Issue List

09-22-25 Firebirds Chesterfield, VA

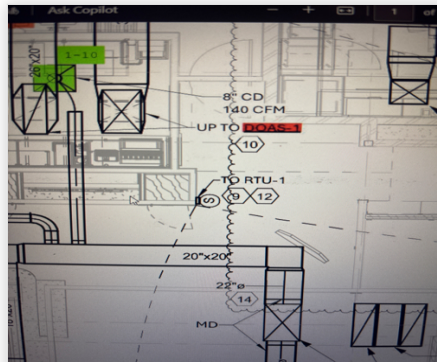
Issue Name : RTU-1 Temperature Sensor
Description : Sensor near beverage zone is not communicating properly with RTU-1.
Created By : National TAB **Assigned To :** National TAB - Antonio Flores-De La Cruz
Status : Open
Priority : High **Asset Tag :**
Originated Date : 09/24/2025 - Antonio Flores-De La Cruz - National TAB
